To: **South Tyneside Council**
From: **Iceni Projects Ltd (Transportation)**
Date: **9th March 2016**
Title: **ST/0955/15/FUL - Former Be Modern Premises, Western Approach, South Shields**

a. Introduction

b. Response to STC Comments

7.5t Box Van Exiting Space in Forward Gear

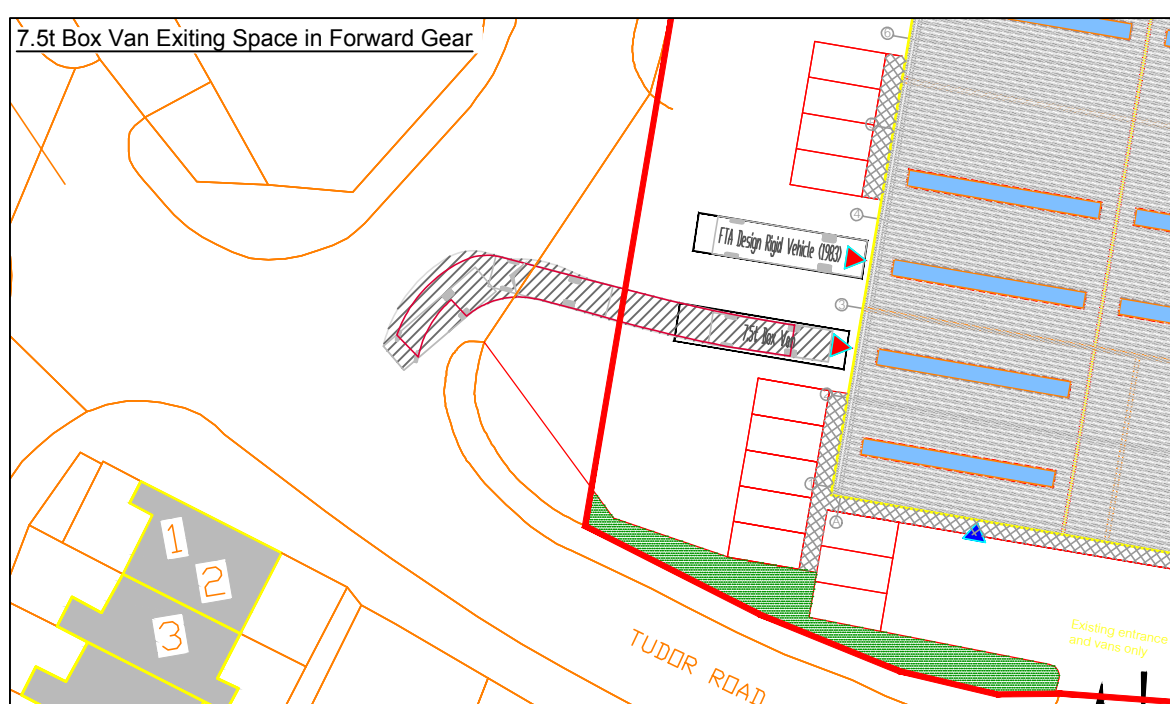
20. *Swept paths have not been produced for all units, can this be provided.*
21. Drawings showing the swept path for service vehicles servicing all units are included at Appendix A4. These show that all units can be accessed by the vehicles that will be servicing them even if a vehicle is parked at the adjacent loading door.
22. *The swept path produced for unit 2 shows that a 16.5m vehicle would need to use the Travis Perking yard (requiring the gates to be open). The analysis doesn't seem to make use of the turning head within the manoeuvre.*
23. The swept path for unit 2 has been redone utilising the turning head to manoeuvre. This is shown on the drawings included at Appendix A4.
